# METROPOLITAN GOVERNMENT OF NASHVILLE AND DAVIDSON COUNTY

## STAFF RECOMMENDATION 0 Douglas Avenue February 18, 2015

**Application:** New construction-infill  
**District:** Eastwood Neighborhood Conservation Zoning Overlay  
**Council District:** 06  
**Map and Parcel Number:** 08302019500  
**Applicant:** Van Pond, Jr.  
**Project Lead:** Paul Hoffman, paul.hoffman@nashville.gov

**Description of Project:** The applicant proposes new construction of a two-family residence on this vacant lot.

ELEVATIONS

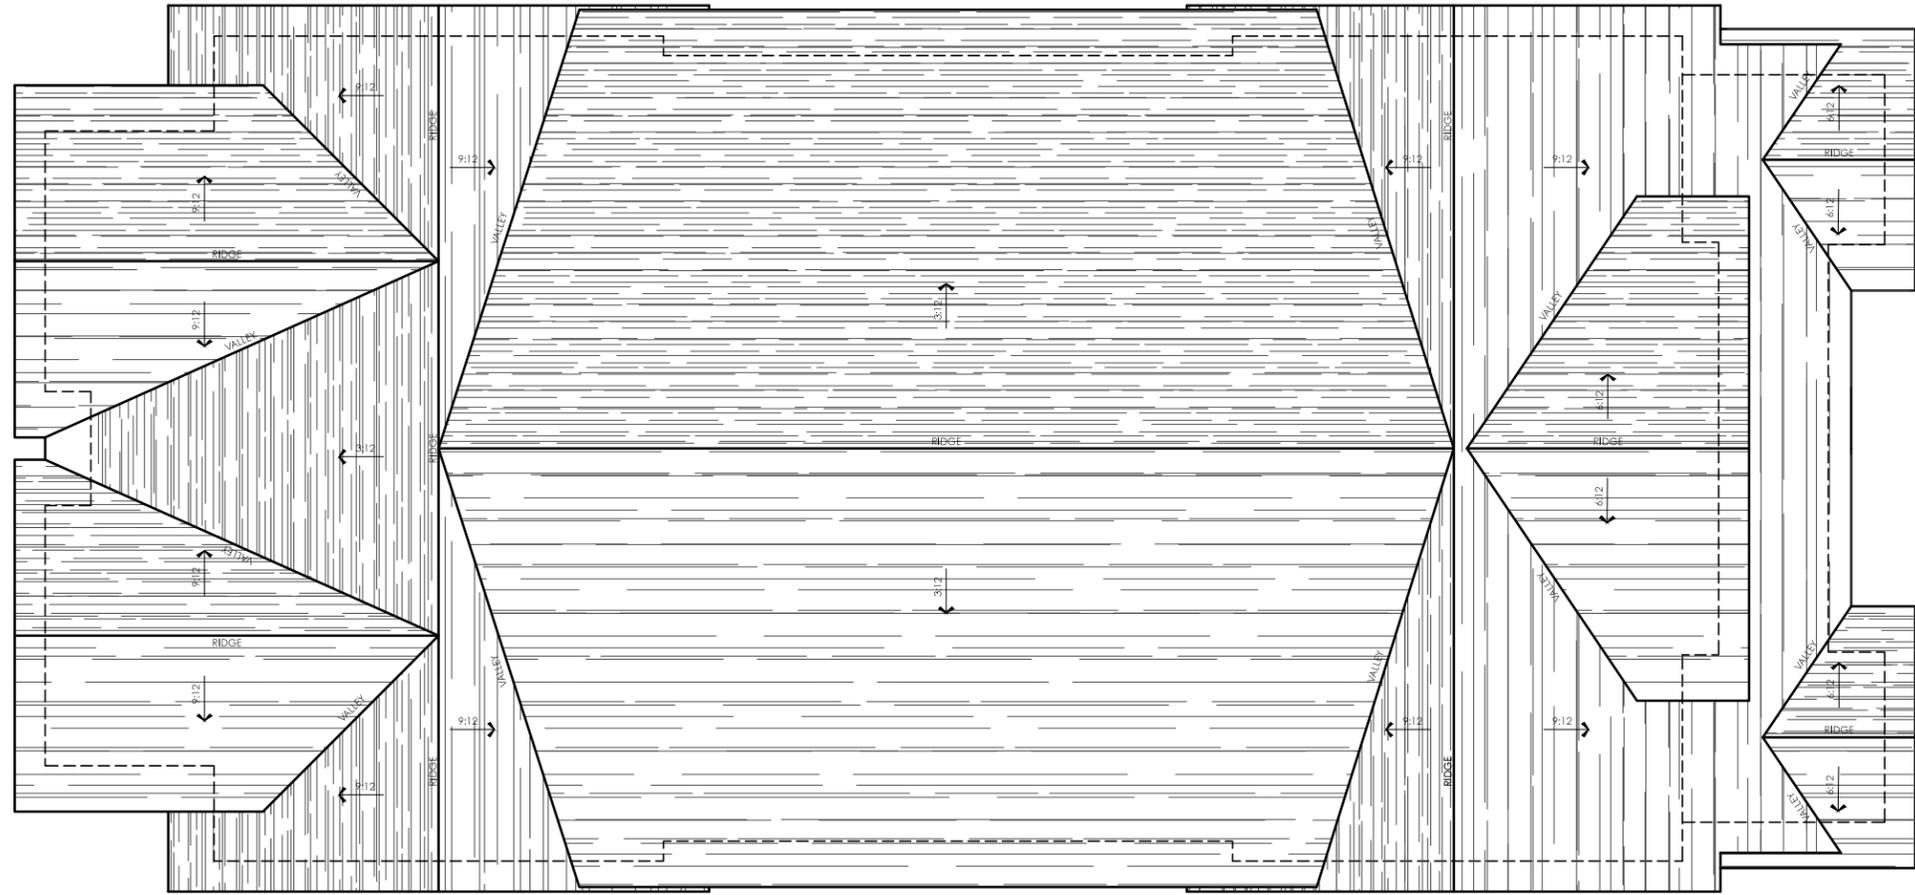
Height & Scale: The new building will be thirty-six feet (36') wide and have a ridge height of twenty-five feet, five inches (25'5") from grade. Neighboring houses range in width from twenty-eight to thirty-eight feet (28'-38') and in height from nineteen to twenty-seven feet (19'-27') from grade. This proposed infill is within the height and width range of the context. The foundation height will be one foot, four inches (1'4"). The proposed eave height of eleven feet (11') and the porch height of fifteen feet (15') from grade are compatible with the neighboring buildings. The project meets section II.B.1.a. and b.

Materials: The primary siding will be smooth-faced fiber cement siding. Siding reveal was not noted; Staff requests the reveal be no greater than five inches (5"). The porch gable fields and dormer will be fiber cement board-and-batten. The trim will be fiber cement or wood. The building's foundation will be split-face concrete block. Roofing will be architectural shingles. The color of the roofing was not specified. Staff asks for approval of the roofing color. The porches will have concrete slabs and steps; the rear porch has pressure-treated wood steps. The porch columns will be fiber cement. The windows will be wood windows. Staff asks for final approval of windows and doors. With the staff's final approval of the roofing color, and windows and doors, and that the siding have a maximum reveal of five inches (5"), staff finds that the known materials meet section II.B.1.d

① Proposed Main Floor Plan

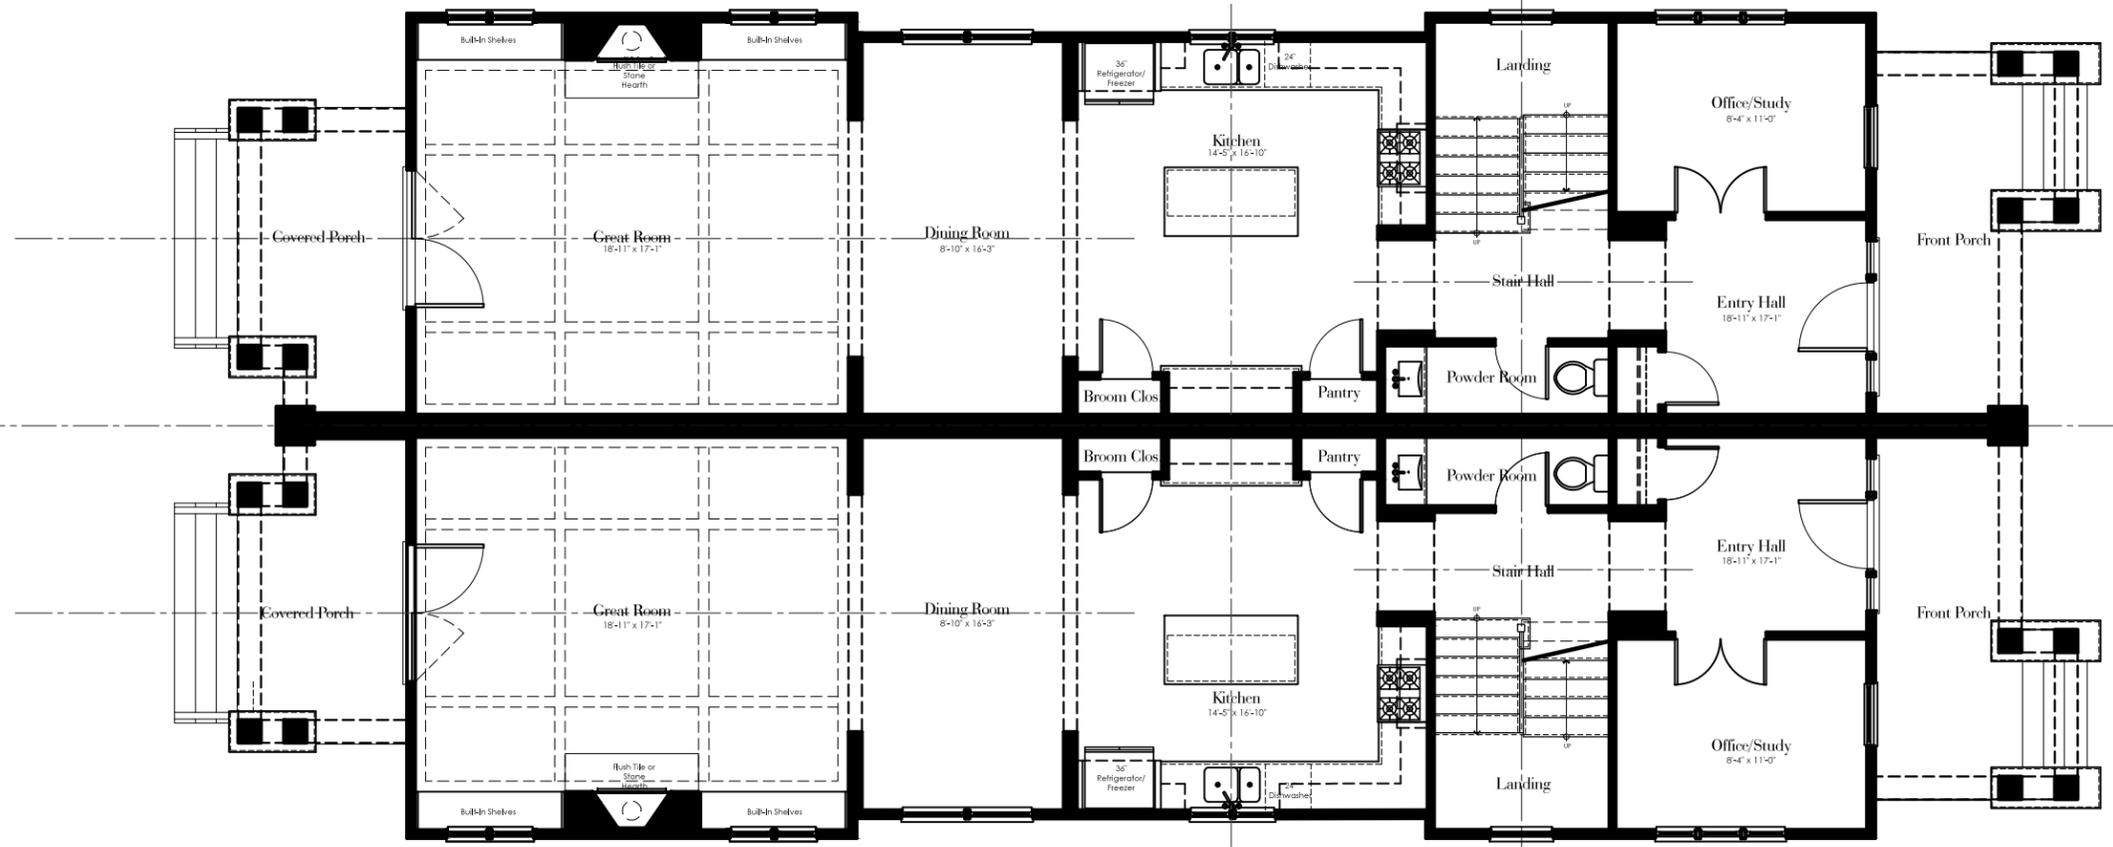
Orientation: The building addresses Douglas Avenue in a manner consistent with neighboring buildings. Each unit has a porch facing the street. Both front and rear porches are drawn with a wall down the middle; the Commission has recently approved a similar design at the rear, but not at the front of the house. Staff recommends the front wall be removed. The site plan does not indicate walkways. Staff recommends a walkway be added to connect the front porch of each unit to Douglas Avenue. The porches are nine feet, nine inches (9'9") deep. Vehicular access was not indicated. With the conditions that the front porch wall be removed, and walkways be added, the project meets section II.B.1.f for orientation.

1. The site plan be resubmitted including the adjacent buildings, in order to verify the front setback;
2. The porch wall separating the two units be removed from the front, as has been required of other similar projects;
3. A walkway be added to connect the front porch of each unit to the street;
4. The finished floor height shall be consistent with the finished floor heights of the adjacent historic houses, to be verified by MHZC staff in the field;
5. Siding have a maximum reveal of five inches (5");
6. Staff approve the roofing color, masonry, windows and doors prior to purchase and installation; and,
7. The HVAC shall be located behind the house or on either side, beyond the midpoint of the house.

Proposed Site Plan

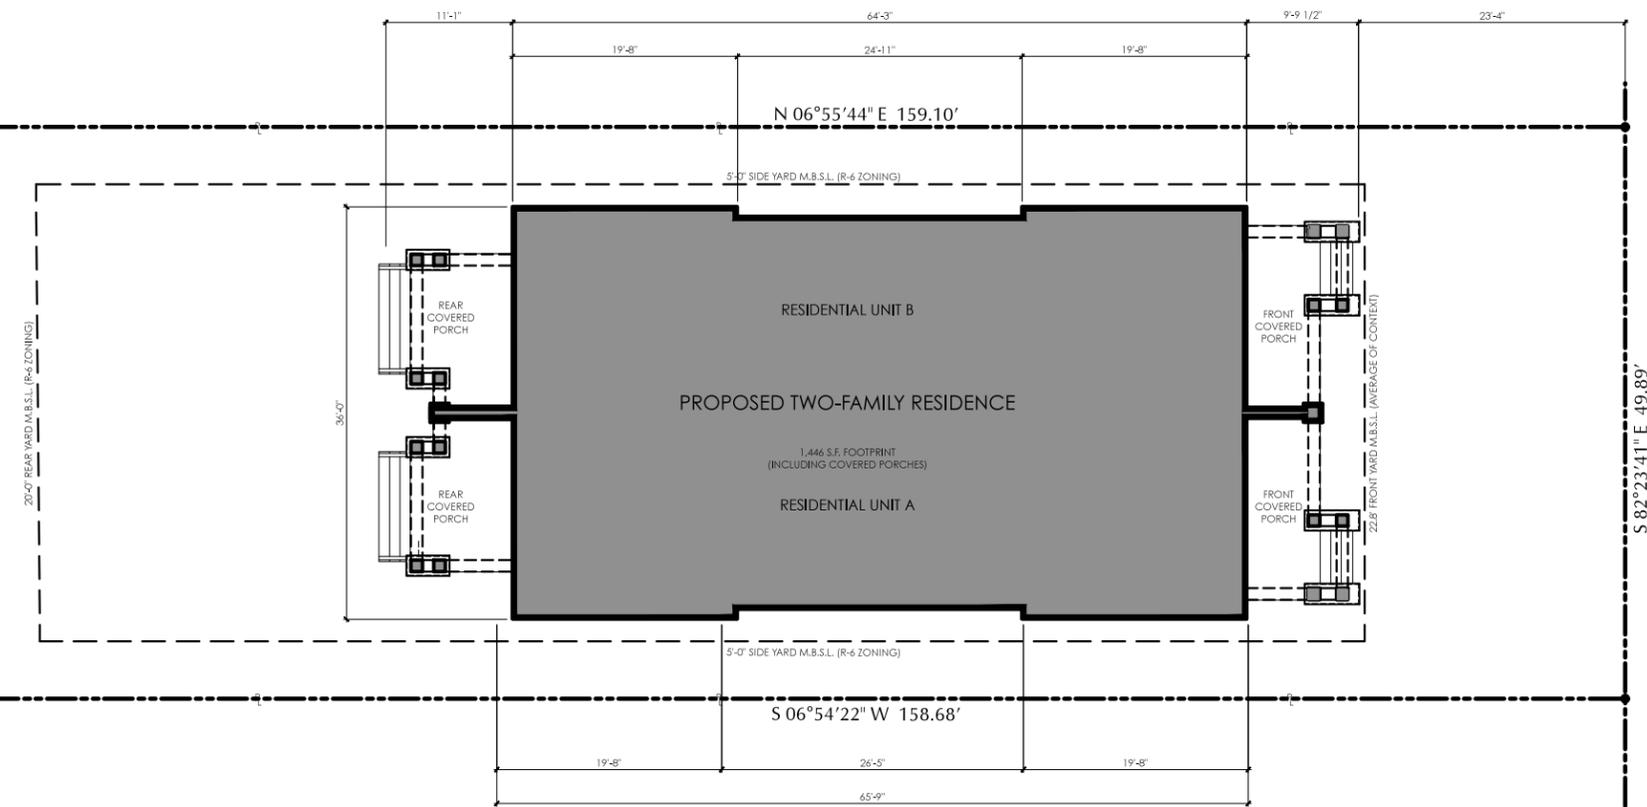
Setback & Rhythm of Spacing: The building's porches are twenty-two feet, eight inches (22'8") from the front property line. Staff was not able to verify that the setback matches the neighboring houses as the submitted site plan does not include the adjacent buildings. Staff requests the site plan be revised to include the adjacent buildings, in order to verify the street setback. The side setbacks are seven feet (7') on each side. The rear wall of the building will be approximately fifty-three feet (53') from the rear property line. These setbacks meet the base zoning requirements of five feet (5') on the sides and twenty feet (20') from the rear. With the revised site plan, the project meets section II.B.1.c.
